**Addendum #1**  
**June 10, 2024**

**Westbrook Armory MOV/POV Compound Project, Westbrook, Maine - Project No. 23SR19-428-D**  
**Bid Number #24-047**

Directorate of Facilities Engineering

**SITE UTILITY PLAN**  
 SCALE: 1"=20'

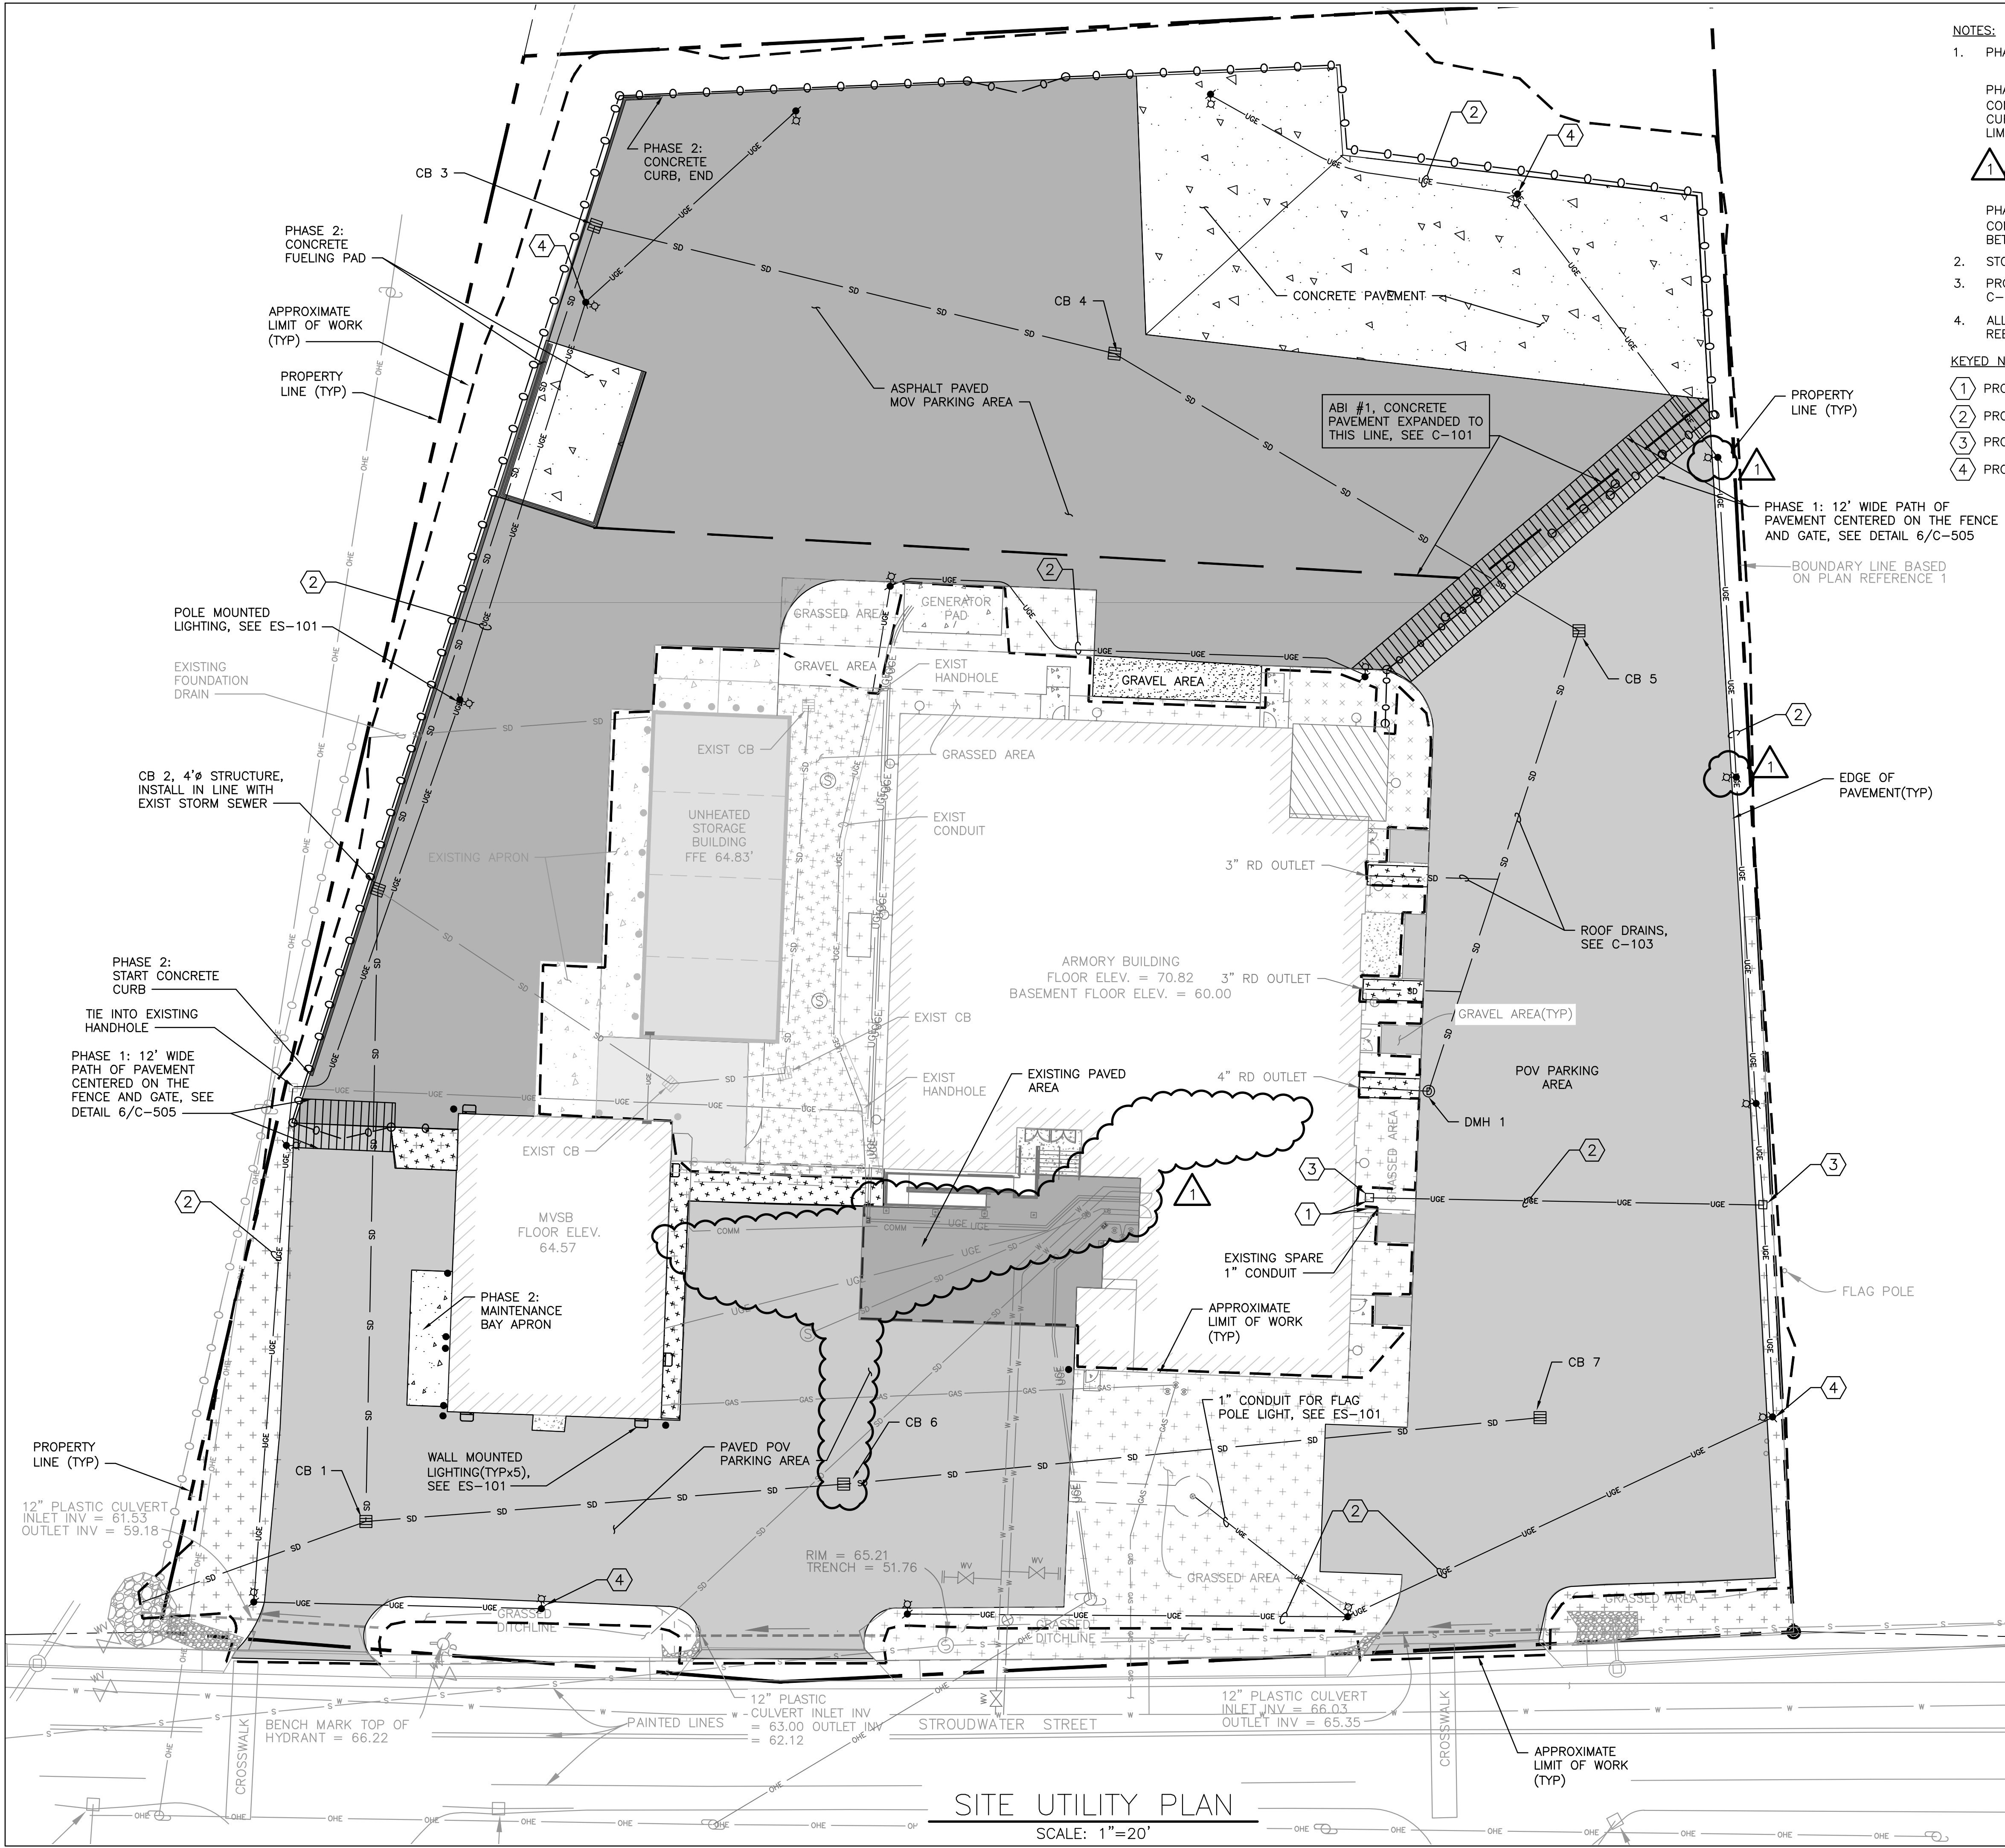
- e. C-102 - Eliminates foundation drain and cleanouts as well as the EV charging station.
  - f. C-103 - Eliminates 6" Perf HDPE . Also allows for emplacement of concrete and pads during Phase I provided it meets the conditions set forth in the the addendum note.

**3 LIGHT POLE BASE**  
NOT TO SCALE C-101

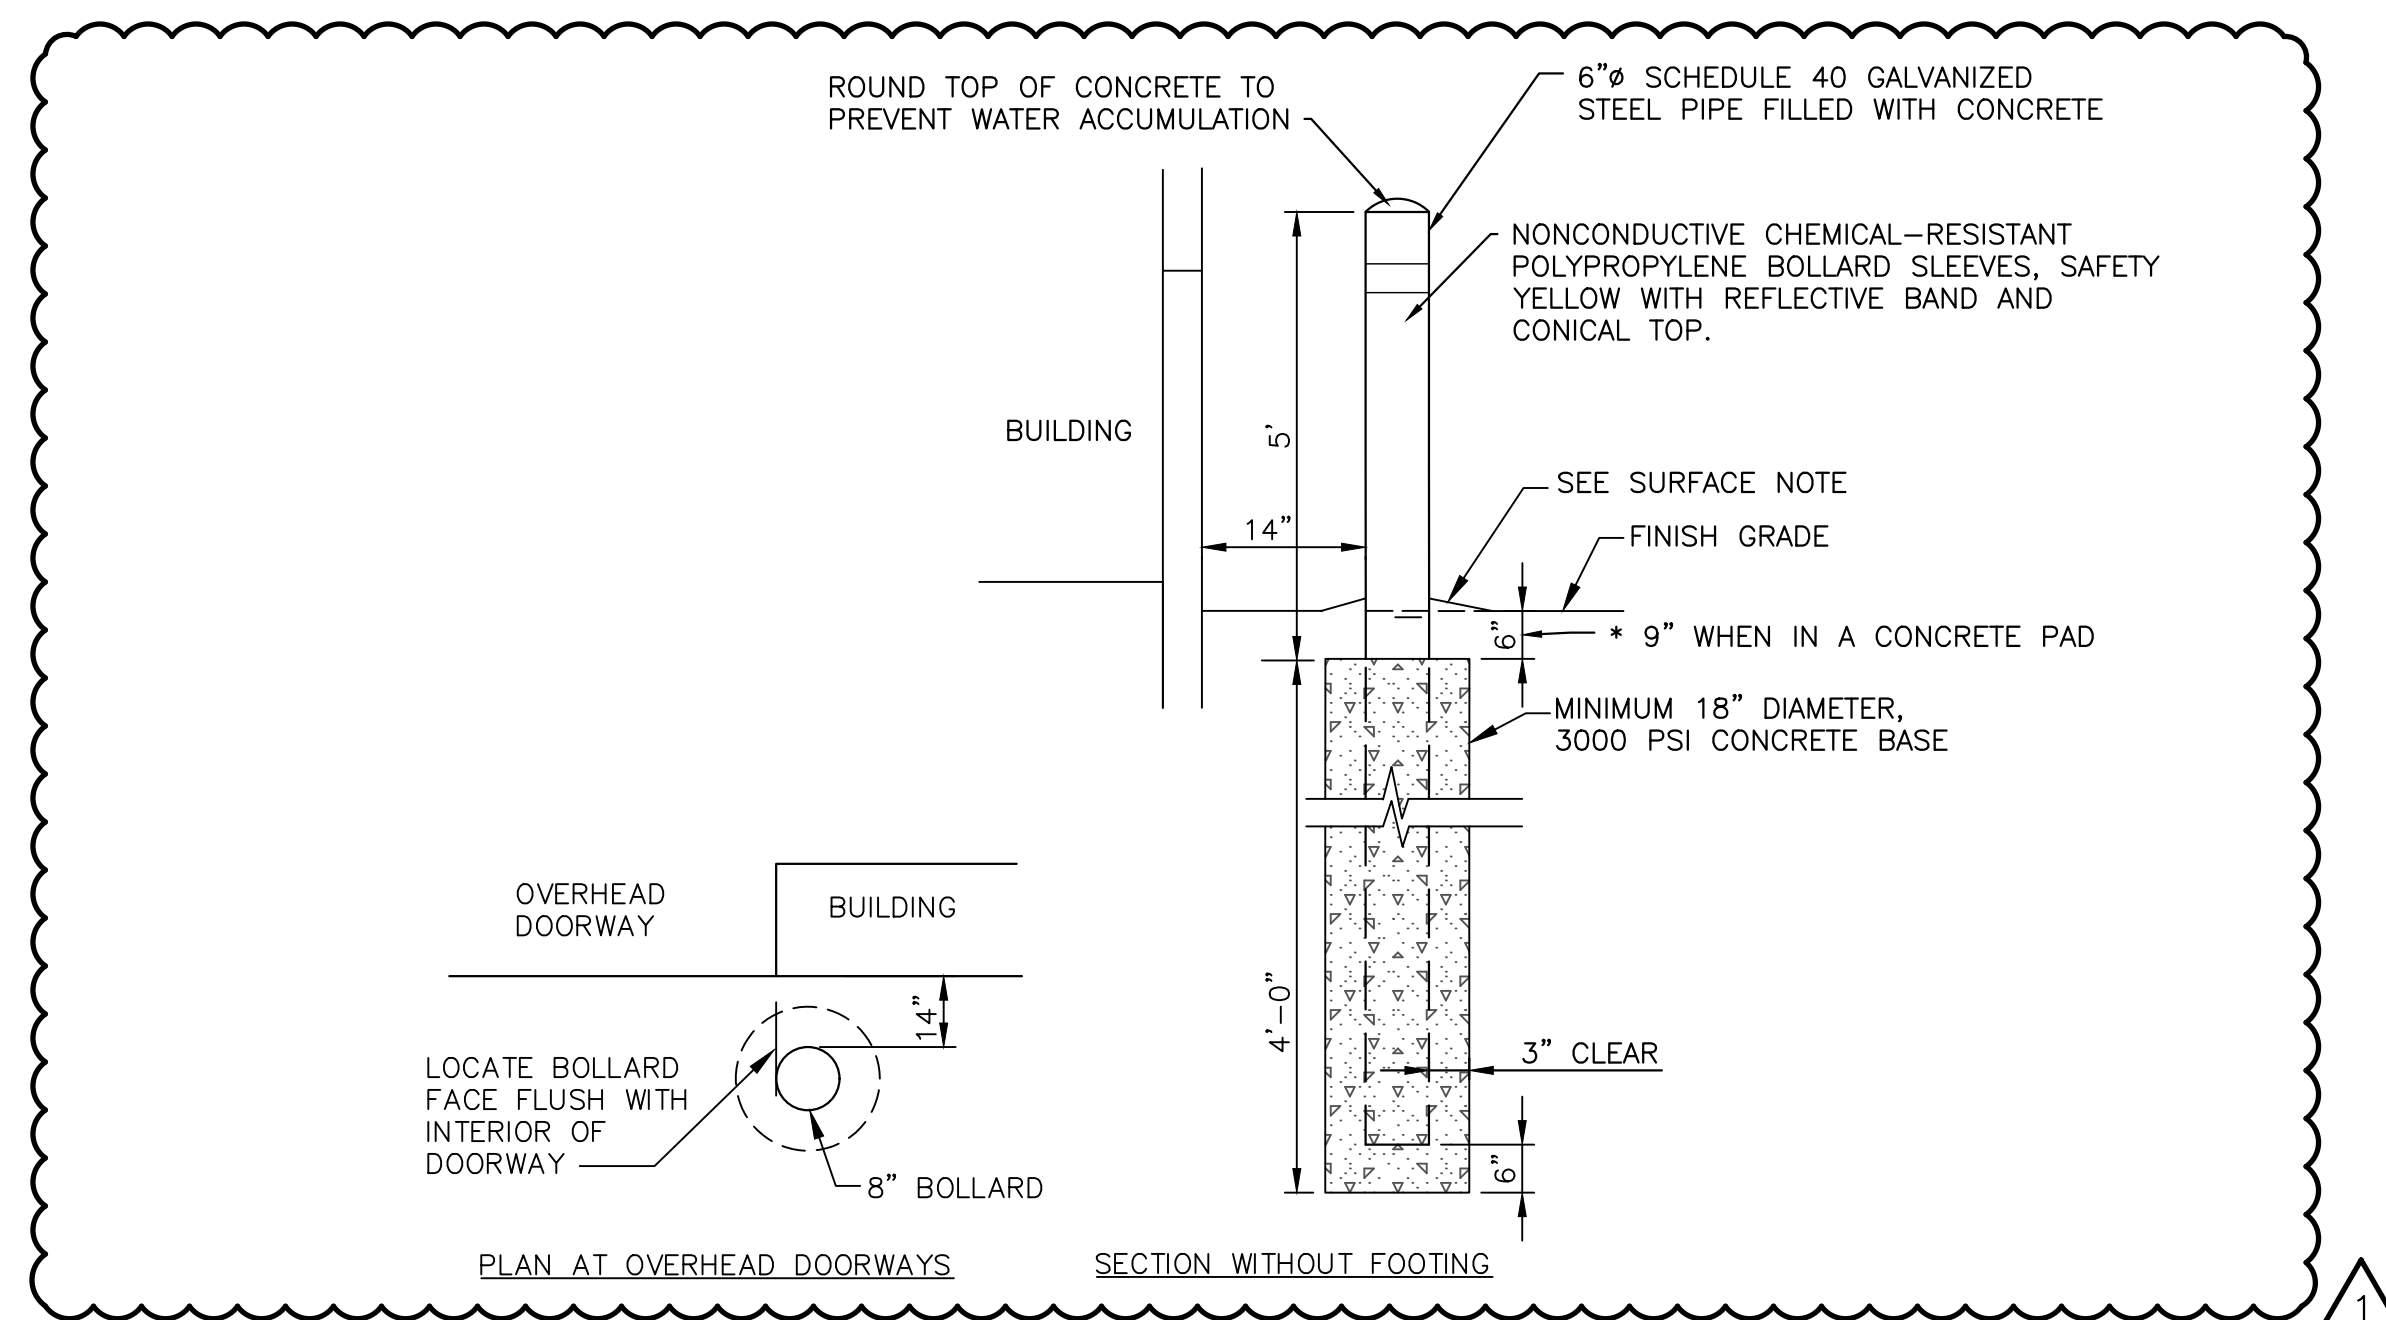
11. Light pole bases on drawing C-101 says 2' diameter; detail D-3 on drawing C503 says 3' diameter. **All light pole bases are 3' in diameter. Please note that the locations of two light poles on the east side of the site have been moved off the pavement.**

**7 TYPICAL BOLLARD DETAIL**  
NOT TO SCALE C-101

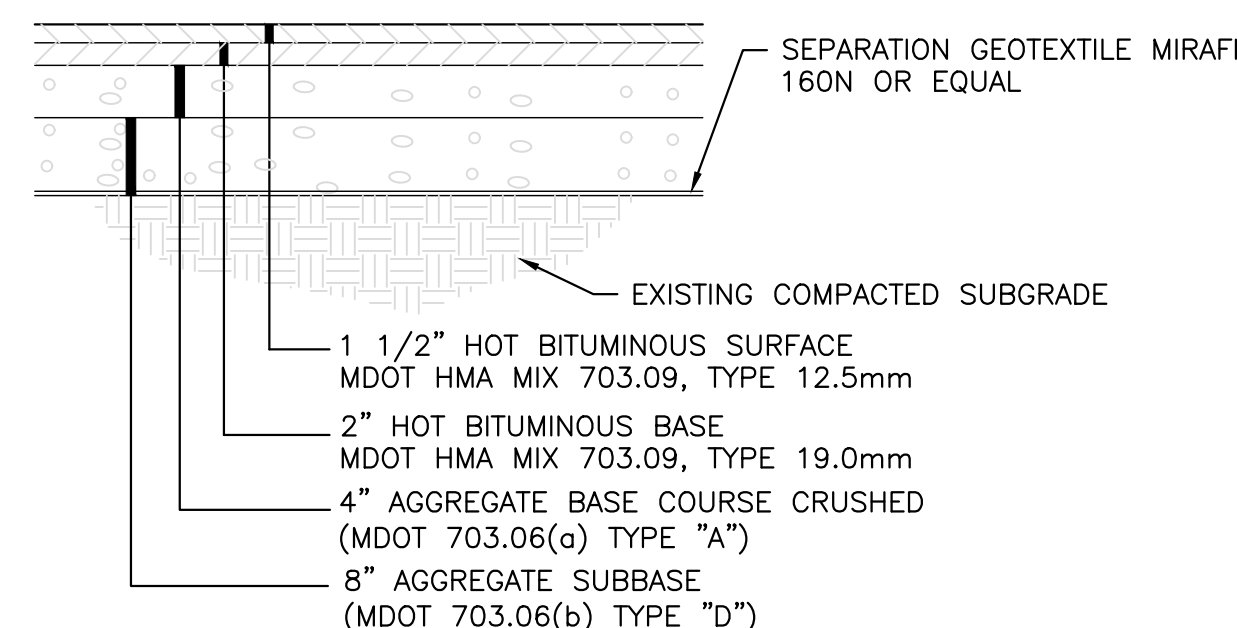
- g. C-503 - Removed the section with footing detail portion from the Typical Bollard Detail.
- f. ES-101 - Eliminates EV charging station and shows an adjusted location for light poles.

9. Detail 7 page C-101 shows bollards with and without footings. Please clarify which, if any, bollards need to be integrated into footings. **All bollards are to have 18" diameter cast in place footings as shown in detail 7 on Sheet C-503. None of the bollards are to be integrated into the footings.**

10. The same detail also shows 8" and 6" bollards. Please clarify the bollard pipe diameter. **All bollards are 6" galvanized steel schedule 40 filled with concrete.**

12. Are steel bollards with precast bases an acceptable alternate? **No, all bollard foundations must be cast in place.**
